N5242A-07A

**S E R V I C E N O T E**

Supersedes:  
N5242A-07

N5242A PNA Series Microwave Network Analyzers

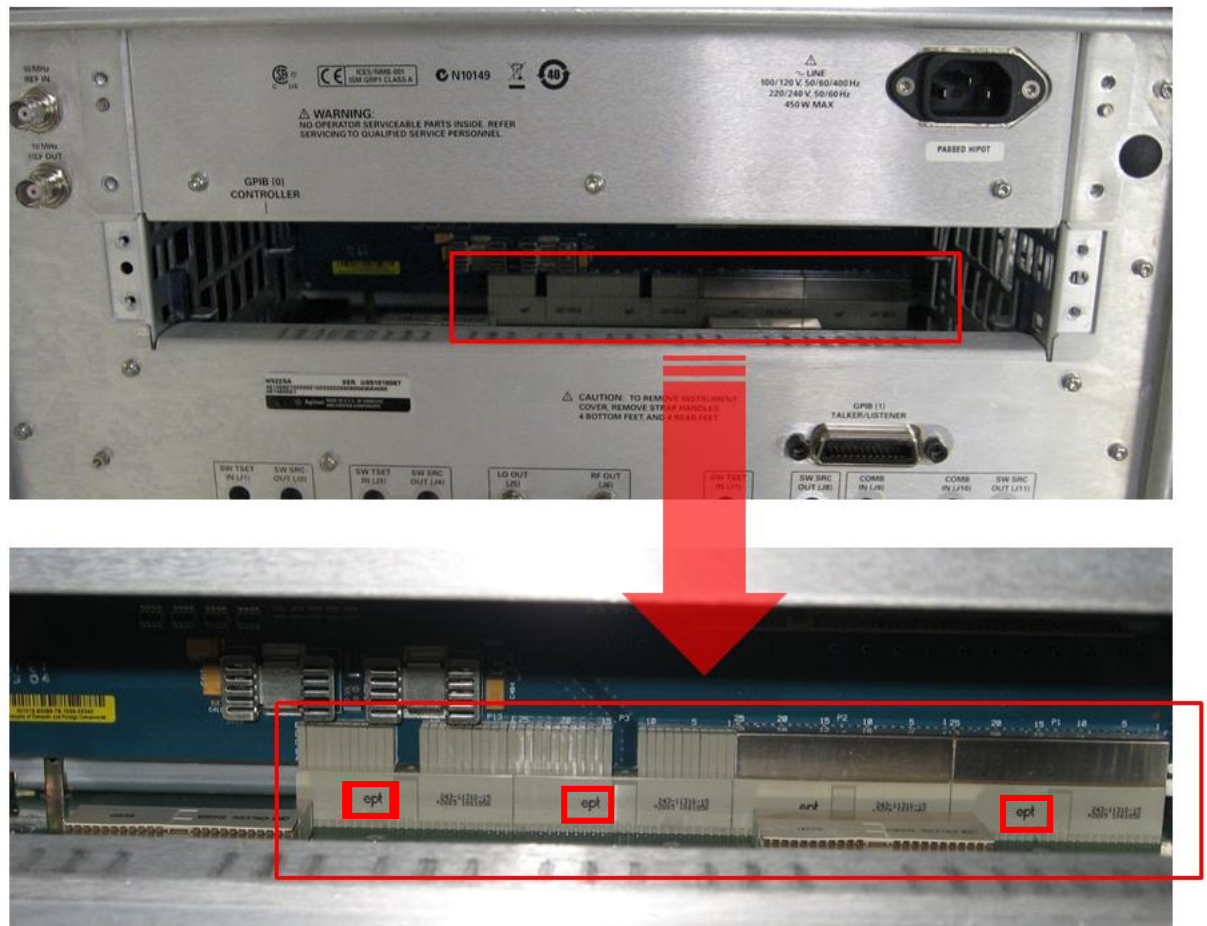
1. Remove the CPU assembly from the analyzer's rear panel. Refer to the PNA Service Guide chapter 7 section titled, "Removing and Replacing the CPU Board Assembly" for removal and reinstallation procedures. To view the online Service Guide, see the numbered list on the next page for instructions.
2. As per the photo below, inspect the system motherboard connector to see if it has one or more "ept" logos.

3. If the connector has one or more “ept” logos, return the analyzer to Agilent for replacement of the system motherboard. If the connector does not have one or more “ept” logos, email [ctd-soco\\_support@agilent.com](mailto:ctd-soco_support@agilent.com), providing the analyzer model and serial number and details of the malfunction symptoms.

4. *For Agilent Service Technicians only:* Only new boards without “ept” logos should be installed. Before installing the new board, look to see if it has one or more “ept” logos. If so, email [ctd-soco\\_support@agilent.com](mailto:ctd-soco_support@agilent.com), providing the analyzer model and serial number. Wait for further instructions in an email reply. New boards without “ept” logos can be installed. For installation instructions, refer to the PNA Service Guide chapter 7 section titled, “Removing and Replacing the System Motherboard.” To view the online Service Guide, see the numbered list on the next page for instructions.
